Re: 49 CFR Part 573; Recall of Mercedes-Benz M-Class

Campaign No.2003040005
 May 2003, Revised June 2003,
 Revised July 2003

SUBJECT: **MODEL 183,154/157/172/174/175
 REPLACEMENT OF CLAMP FOR LOWER POWER STEERING HOSE DUE TO
 POSSIBLE FLUID LOSS AT RADIATOR**

This revised Recall Campaign 2003040005 supercedes previously issued Recall Campaign 2003040005 released in June 2003. It contains new and updated repair and warranty information, please destroy previous versions.

Figure 1

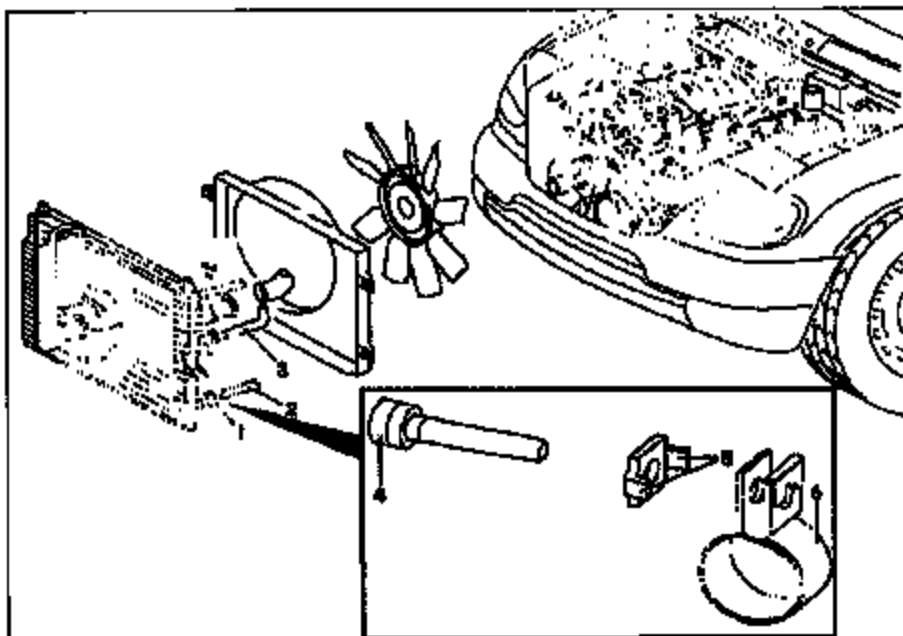
DCAG has determined that the lower power steering hose clamp (1, Figure 1) located on the lower power steering hose (2, Figure 1) at the lower left hand corner of the radiator must be replaced, with a new clamp (6, Insert, Figure 1). The hose clamp may not provide sufficient clamping force for this connection and may cause fluid loss.

Figure 2

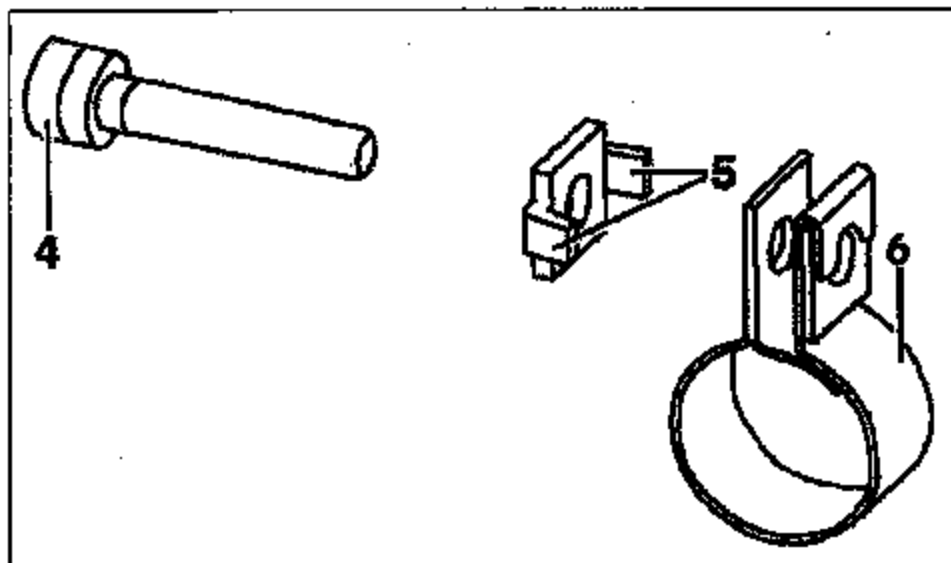
7. Open replacement hose clamp (6, Figure 2) just enough for clamp to fit over the outer circumference of the lower power steering hose (2, Figure 1).

1 NOTE: The new replacement hose clamp (6, Figure 2) must have the number "Nr St 16" stamped into the outer circumference of the hose clamp surface. Any other type of hose clamps must not be used.

8. Slide the installed new hose clamp toward the radiator and locate in the proper position on the lower steering hose (1, Figure 1) as shown and tighten hose clamp screw (4, Figure 2).

Observe tightening torque of: Nm 2.0 + .5 / - 0.0 and proper orientation of the anti-rotation tabs (5, Figure 2).

Figure 4 (shown on vehicle with banjo bolt fitting, vehicle may be equipped with compression fitting)

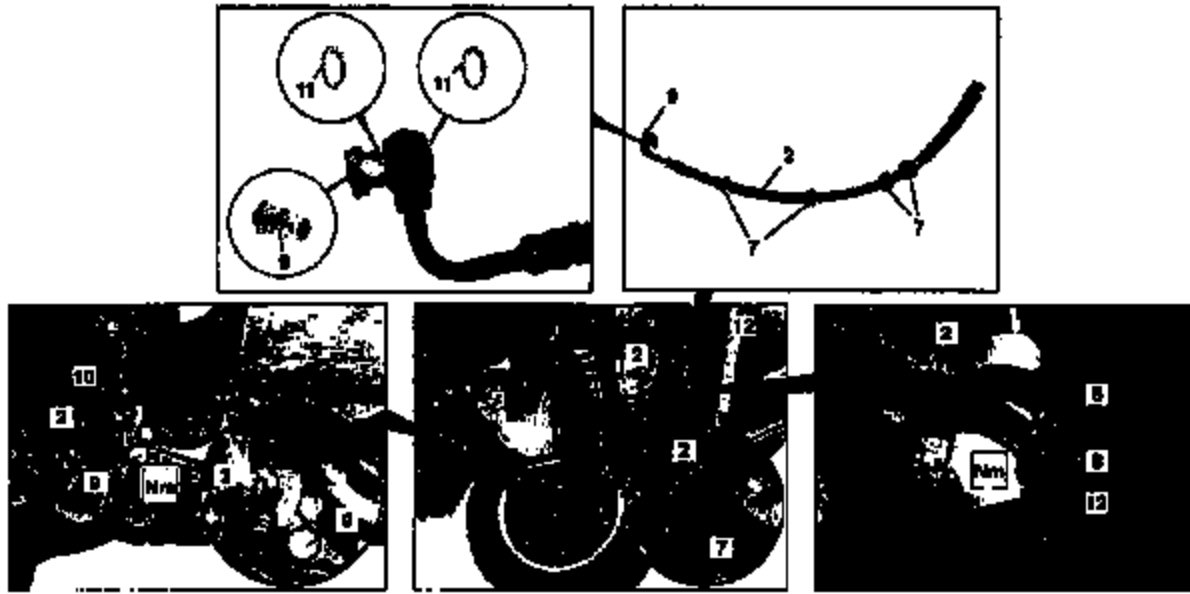
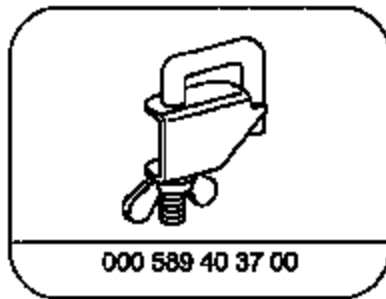
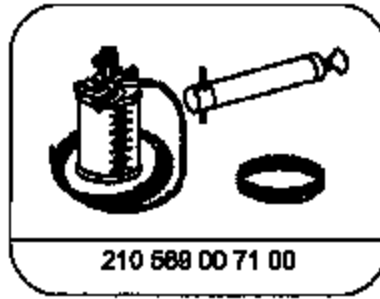
- Detach lower power steering hose mounting grommets (7, Figure 4) from 4 holders (attached to the frame rail on the left front of vehicle).
 - Loosen new hose clamps (8, Figure 4) and disconnect lower power steering hose (2) from radiator fitting.

- Remove banjo bolt (9, Figure 4) securing lower power steering hose (2) to power steering rack (10) and remove power steering hose by routing out towards rear of vehicle.

- Install new power steering hose (2, Figure 11) in reverse order (reuse new hose clamp with "Nr 54 15" stamped on the exterior).
 - Ⓟ Install new sealing rings (11, Figure 4) (or rubber O-ring if equipped with flare fitting) when installing new lower power steering hose (2)
